Access Compliance Report Public Rights-of-Way (Curb Ramps)

Main Street: JACKSON_ST Cross Street: ELMORE_WAY Location: NE

ADA ID: RPRK211005141943 Ramp Type: Type 1 - Perpendicular Diagonal Initial Pass/Fail: Fail Overall Compliance: No Severity Score: 32

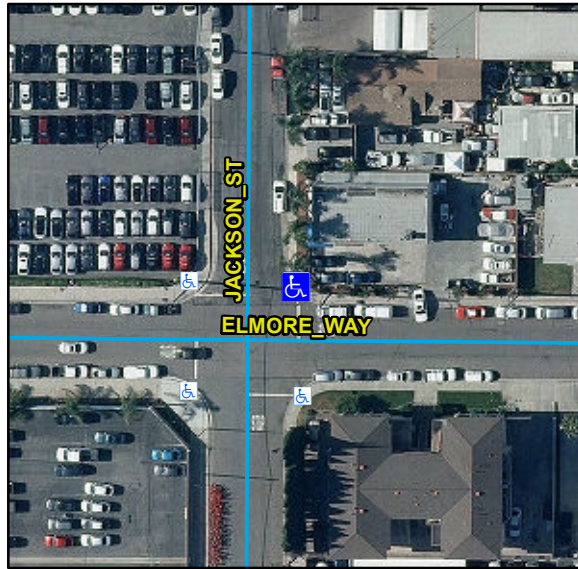
Compliance	Description	Data	Compliance	Description	Data
N/A	Ramp Length (in)	56	N/A	Flare Type LT	
Yes	Ramp Width (in)	48			N/A
No	Ramp Run Slope (%)	14	N/A	Flare Slope LT (%)	N/A
No	Ramp Cross Slope (%)	4.7	N/A	Flare Traversable LT	N/A
N/A	Landing Present	N/A	N/A	Flare Type RT	
N/A	Landing Length (in)	N/A			N/A
N/A	Landing Width (in)	N/A	N/A	Flare Slope RT (%)	N/A
N/A	Landing Run Slope (%)	N/A	N/A	Flare Traversable RT	N/A
N/A	Landing Cross Slope (%)	N/A	N/A	DWS Provided	N/A
N/A	Landing Movement Obstructed?	N/A	N/A	DWS Contrast	N/A
	Landing Movement Type	N/A	N/A	DWS Length (in)	N/A
N/A	Landing Shared	N/A	N/A	DWS Full Width	N/A
N/A	Clear Space	Yes	N/A	DWS Offset Left (in)	N/A
N/A	Clear Space To Crosswalk (in)	N/A	N/A	DWS Offset Right (in)	N/A
N/A	Marked Crosswalk 1	No	N/A	Marked Crosswalk 2	No
	Crossing 1 Direction	W		Crossing 2 Direction	S
	Marked Crosswalk 1 Width (in)	N/A		Marked Crosswalk 2 Width (in)	N/A

N/A	Ramp Inside Crosswalk 1	N/A	Yes	Ramp Inside Crosswalk 2	N/A
	Crossing 1 Slope (%)	4.3		Crossing 2 Slope (%)	0.3
	Crossing 1 Cross Slope (%)	2.4		Crossing 2 Cross Slope (%)	2.7
N/A	Gutter Ponding	N/A	N/A	Curb Slope	1.2
No	Gutter Lip Height (in)	0.5		Road Run Slope (%)	0.1
N/A	Gutter Run Slope (%)	N/A		Road Cross Slope (%)	0.2
N/A	Gutter Cross Slope (%)	N/A			
Yes	Overall Surface Condition: Acceptable		Yes	Perp Joint Present	Yes
	Cross Gutter Present?	No		Spandrel Present?	No
	Replace Cross Gutter?	N/A		Replace Spandrel?	N/A

Remove & Replace Curb Ramp With Two New Directional Ramps or Equivalent. Grind Gutter Lip.

R304.2.2, R304.5.3, R302.7.2, STD 1115
